**E-54 Regional Lift Station - RFCSP
Solicitation Number: CO-00537
Job No.: 22-2502**

**ADDENDUM 2
October 25, 2022**

FORCE MAIN CONNECTION NOTES

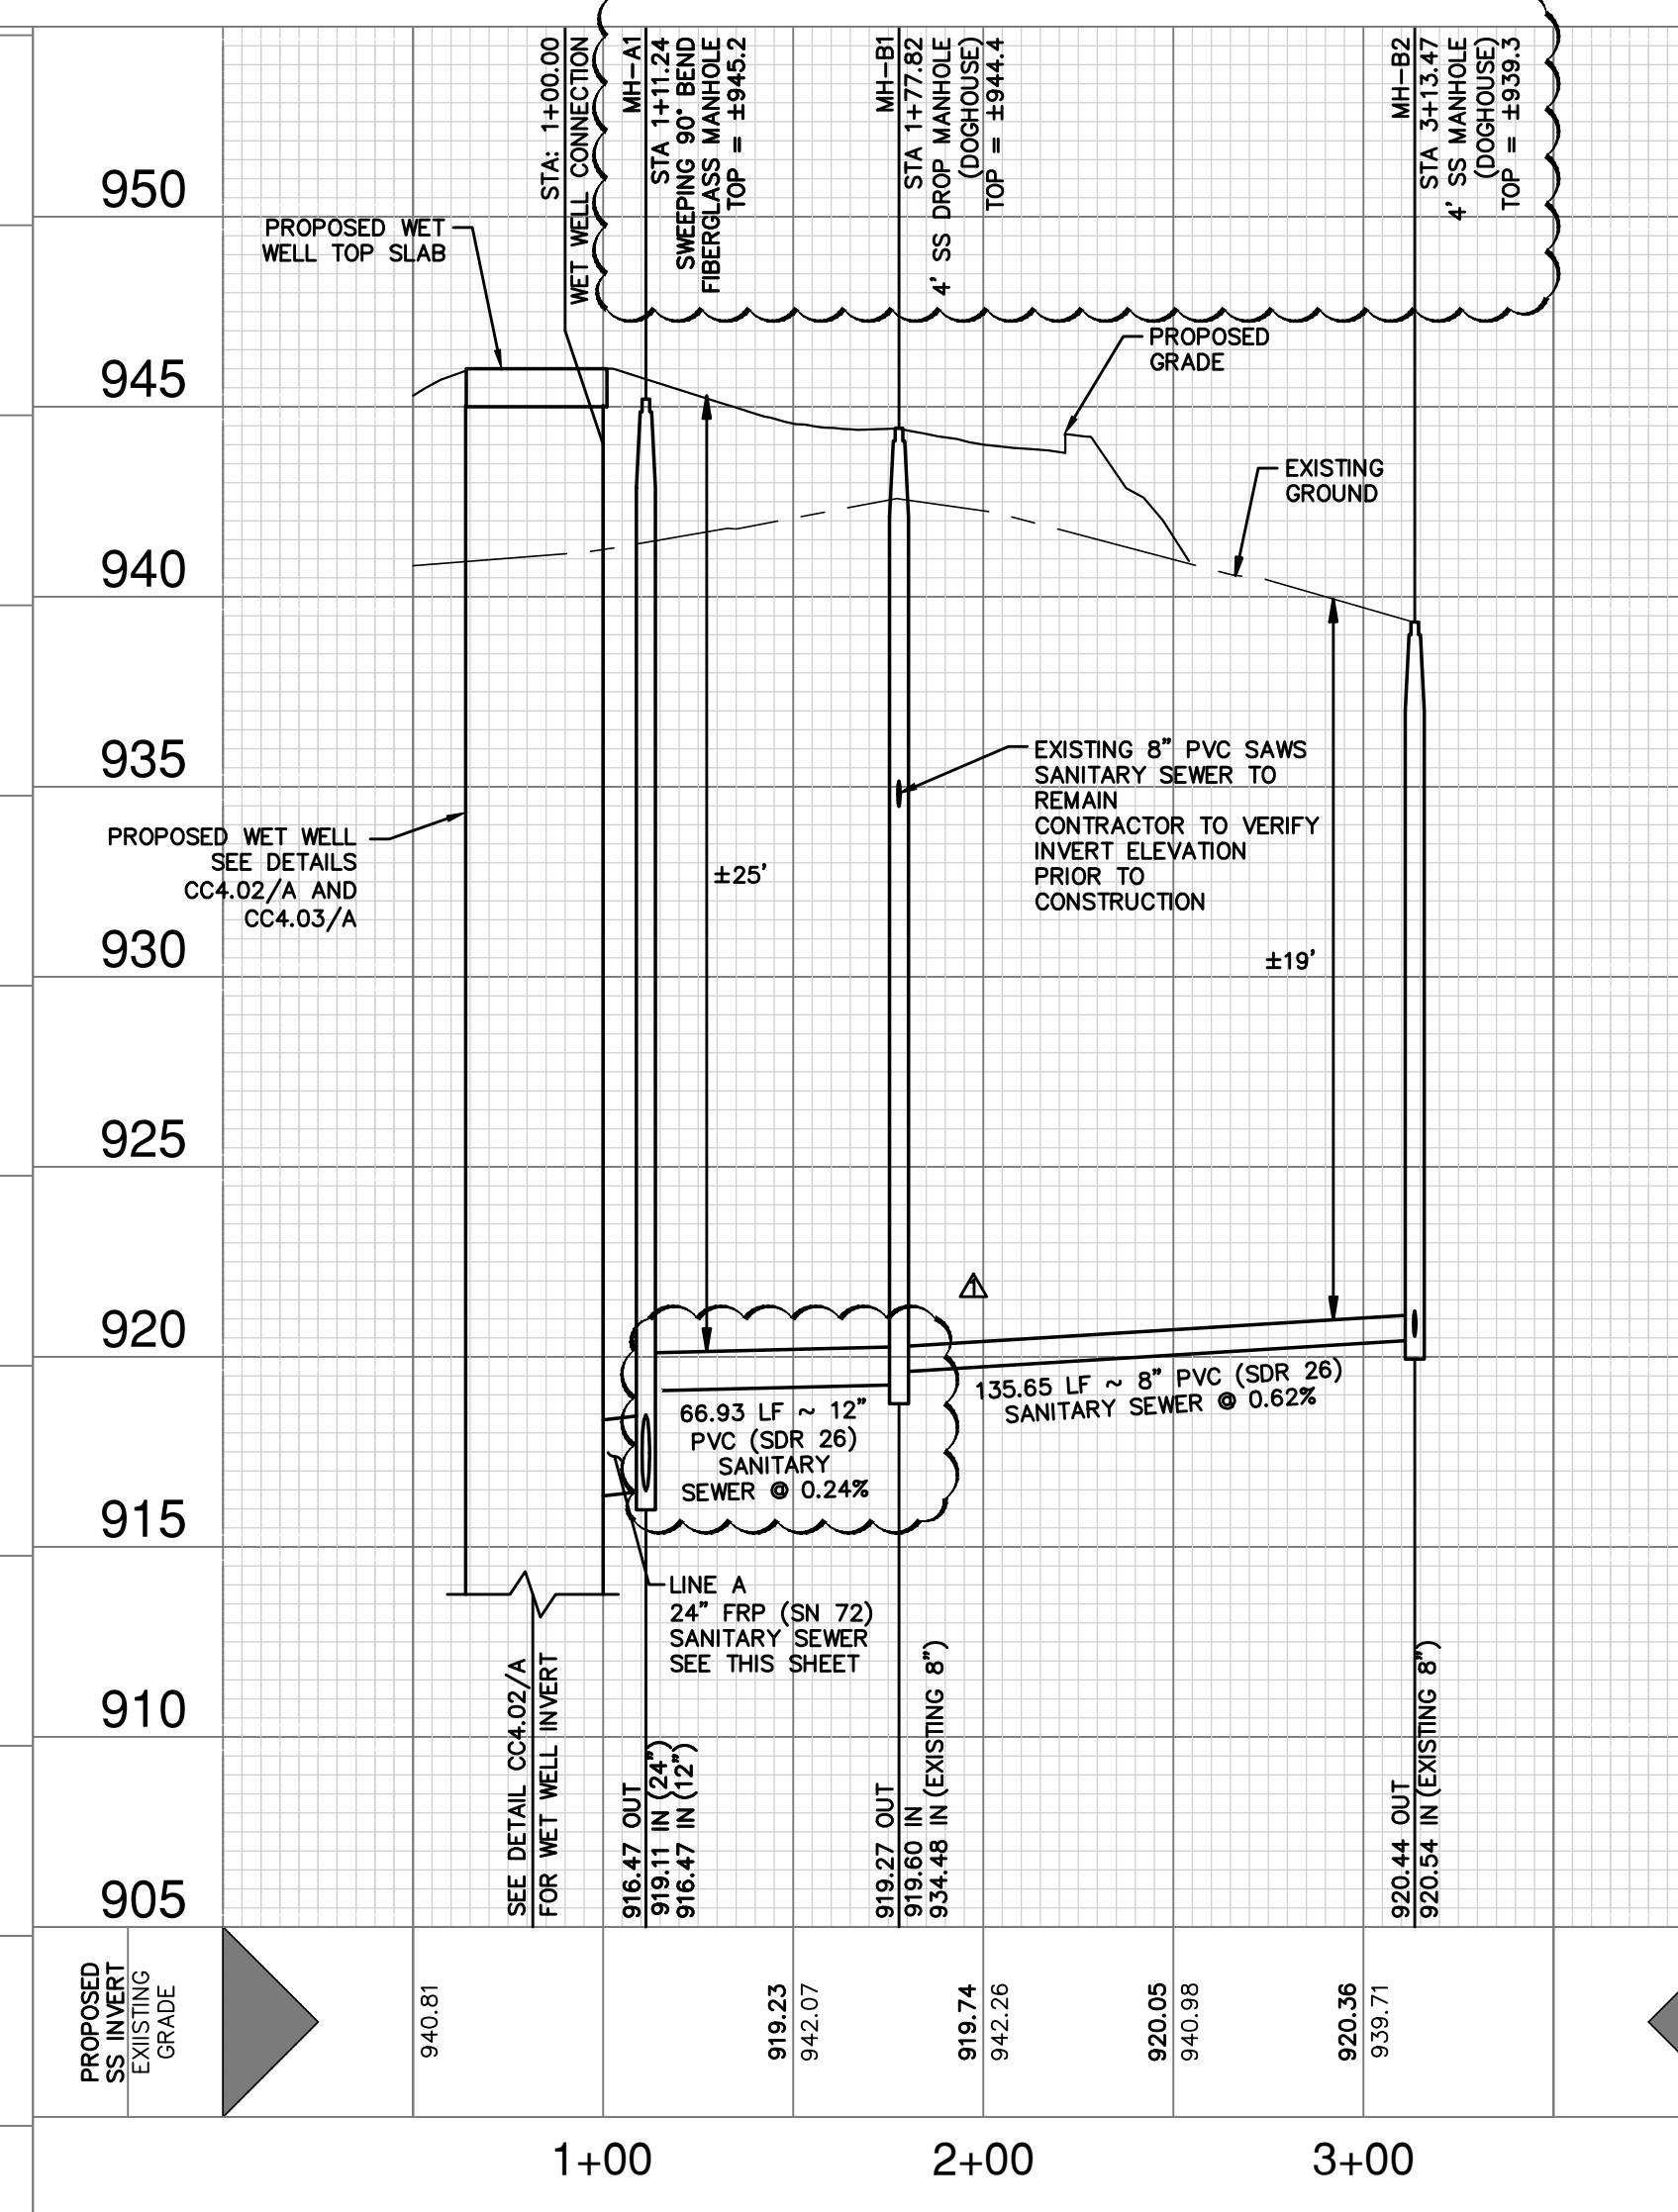
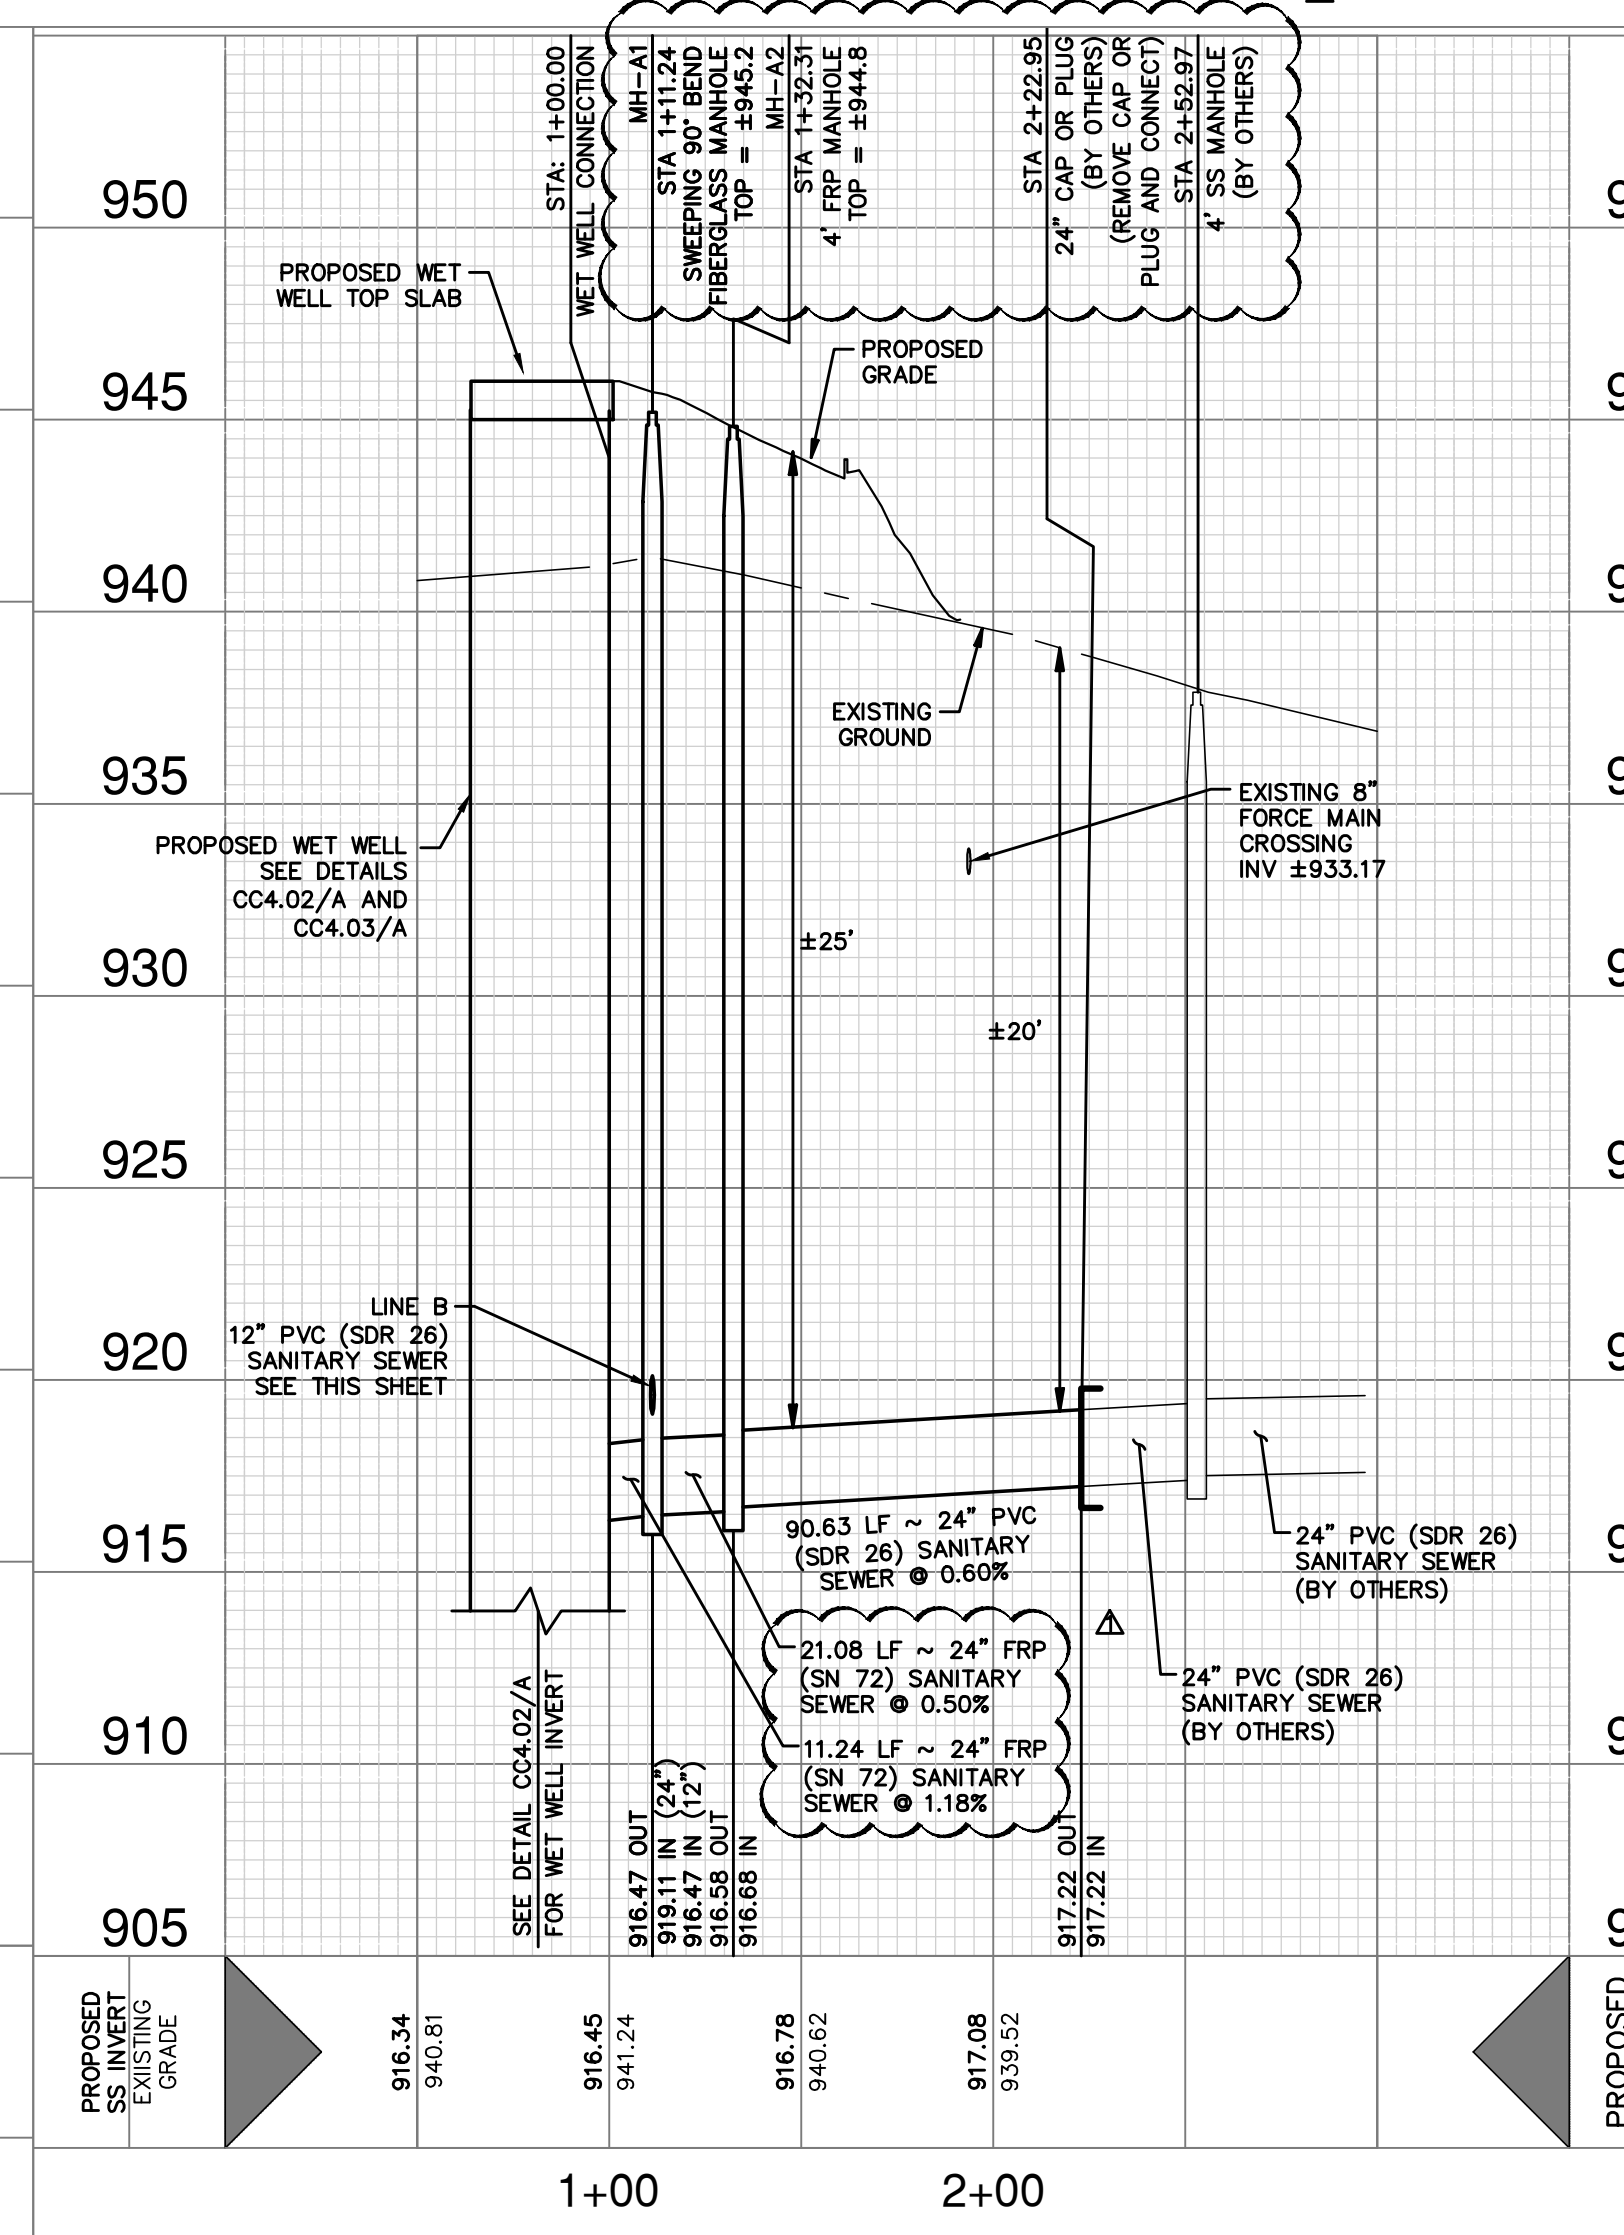
There are discrepancies between dimensions of Sheet E4.00 as compared to E10.00 as well as other electrical building plans. When scaling the foundation of the electrical building on E4.00, it gives a dimension of 32'x14'. Using the scale provided on E10.10 through E10.20 the foundations show to be 37'8"x15'8", same as shown for architectural plans. Site dimensional control Sheet C2.01 seem to indicate the building foundation is 32'x14'. Same goes for other structures on site having different dimensions between site dimensional control plan and individual structural plans. Please clarify which scales are to be utilized.

RESPONSE: Sheet C2.00, C2.01, Sheet C3.00, and E4.00 are revised to show correct interior electrical building and wetwell dimensions and dimensional controls of 36'x14' and interior wetwell dimensions of 35'x35', respectively. Contractor shall refer to structural drawings for foundation perimeter dimensions for these structures. See Changes to the Plans #1, #2, #3, and #9.
